West Island Line Project

Proposal for Alternative Noise Monitoring Stations of  
CN7 and CN11

Figure 1 Alternative Monitoring Locations for CN7a and CN11a

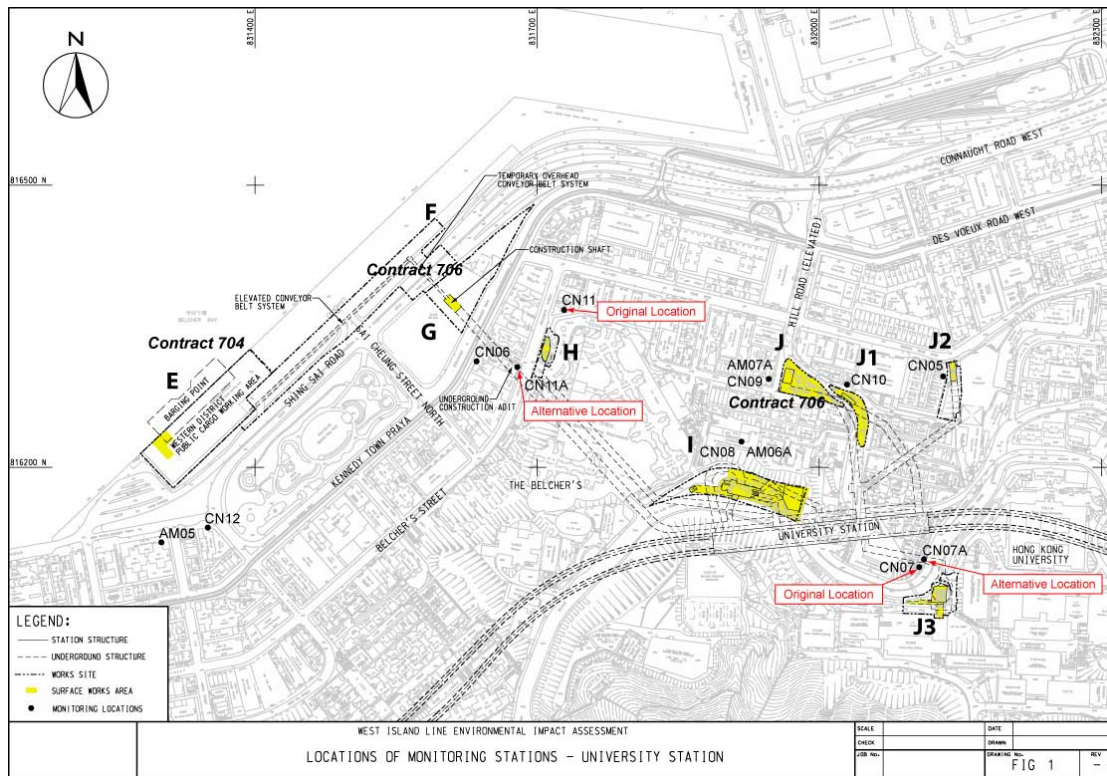
As the premise is being used as services apartment which is fully air-conditioned without openable windows and its name is called “Domus U”. Monitoring at this premise is not applicable in accordance with the EM&A Manual clause 2.11. An alternative location is identified at the adjacent building, Bowie Court as shown in **Figure 1** which satisfies the criteria mentioned above. Access has been obtained from the building management office and representative of the premise.

Discussions were conducted with the building management office and representative of the premise for authorization of access to the premise for the noise monitoring. However, the access was declined by the building management office and representative of the premise. An alternative location is identified at the Yick Fung Garden (Block B) as shown in **Figure 1** which satisfies the criteria mentioned above. Access has been obtained from the building management office and representative of the premise.

The alternative location for CN7 – The Bauhinia is therefore proposed as Bowie Court.

The alternative location for CN11 Sun Shing Building is therefore proposed as Yick Fung Garden (Block B).
